MEB-CQ-201505 10.3.5 Responses

Attachment 1 (1/11)

APR1400 DCD TIER 2

Table 10.3.5-3 (Deleted)

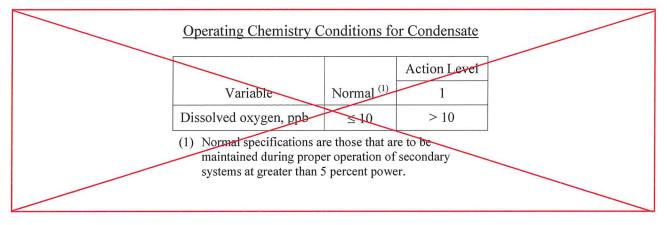
The applicant has provided extensive detail about their water chemistry program. However, a combined license (COL) applicant will need to submit which revision of the EPRI PWR Secondary Water Chemistry Guidelines (EPRI Guidelines) it will use for the details not provided in the certified design.

Please revise APR1400 FSAR Section 10.3.5 to state that the COL applicant, for the details not provided in the certified design, will use the latest EPRI Guidelines revision at the time of COL submittal as the basis for their water chemistry program.

KHNP will revise Section 10.3.5 to add COL 10.3(4) for the COL applicant to use the latest EPRI Guidelines revision at the time of COL submittal as the basis for their water chemistry program. Refer to the markup supplied as Attachment 1.
